Product Change Notification

May, 2015

8100 Common Mode Choke Series Shipping Package Modification & Order Quantity Adjustment

Figure 1

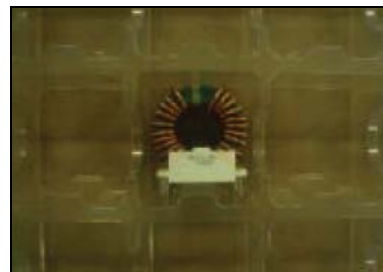
The shipping package of the Bourns® [Model 8100 Series](#) Common Mode Chokes has been redesigned to provide better component protection for normal shipping and handling environments. The original shipping package (Figure 1) offers more limited protection for the components against shock and vibration commonly encountered during shipping and handling processes than the new modified package.

The new modified package (Figure 2) is a portioned plastic tray designed to fit to the contour of each component. Each component is individually placed in a cavity which provides excellent protection against component shifting and tumbling during shipping and handling processes. This new plastic tray package has successfully passed the container drop-test.
